Answers to the comments of Referee #1, #2, #3 and the interactive comment of David Ham corresponding to the article “Observed and simulated turbulent kinetic energy (WRF 3.8.1) over large offshore wind farms”

First of all, we thank the referees for their comments, especially reviewer #2 helped to improve the manuscript. In this document the comments of the referees are plotted in black the corresponding answers are printed in green.

Figure 1: Number of wind turbines per grid cell in the innermost domain (i.e. grid size of 1.67 km) in the previous version (a) and corrected version (b). The grid cells affected by the corrections are labeled (b).

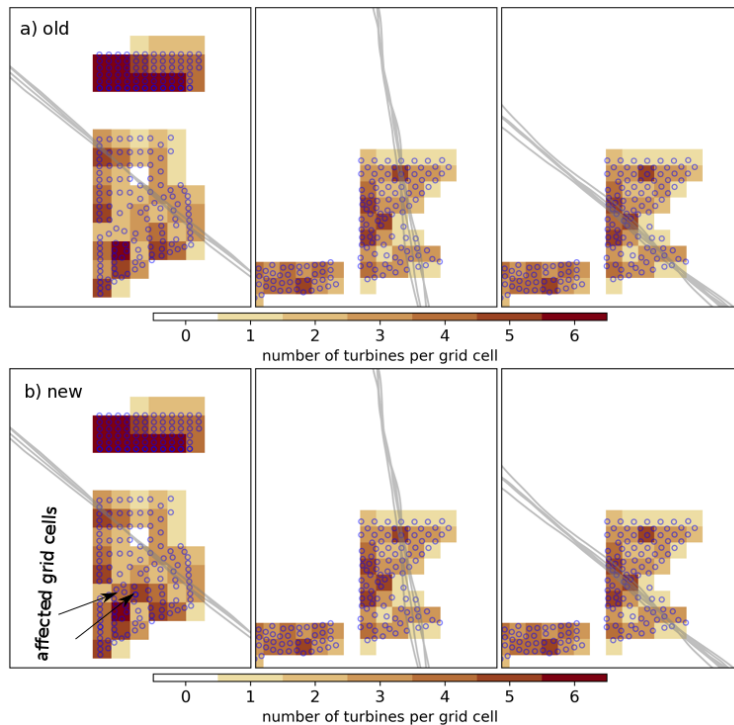
1) The reviewer had experienced problems with the data of the Bundesnetzagentur (coordinates and information such as hub heights and diameters) and knows that these data need to be taken into account with great caution. For instance, the wind farm Meerwind Südost consist of 80 turbines according to the operator [1]. The authors write that only 74 turbines were accounted for! The authors will thus should double check the coordinates and all other information that were taken from the Bundesnetzagentur data and correct all the wrong information and rerun all cases that used wrong specifications.

First things first, we are impressed by the detailed knowledge of the reviewer. This was an important catch although it wasn't having any substantial impact on our results. A comparison of the old and new Figure 2 of the manuscript is shown in Figure 1; two grid cells were affected. Consequently, we also had to redo the simulations and Figures, especially for case study one, where we did measurements over the wind farm Meerwind Süd|Ost.

However, no changes in the TKE along the flight track could be notified as the flight track was located more to the north of the affected grid cells (Fig. 1b). Anyhow, the TKE as shown in Figure 9 in the manuscript, obviously changed as the number of turbines increased in two grid cells (see annotation in Fig. 2b).

Additionally, we double checked all other wind turbine data as pointed out by the reviewer.
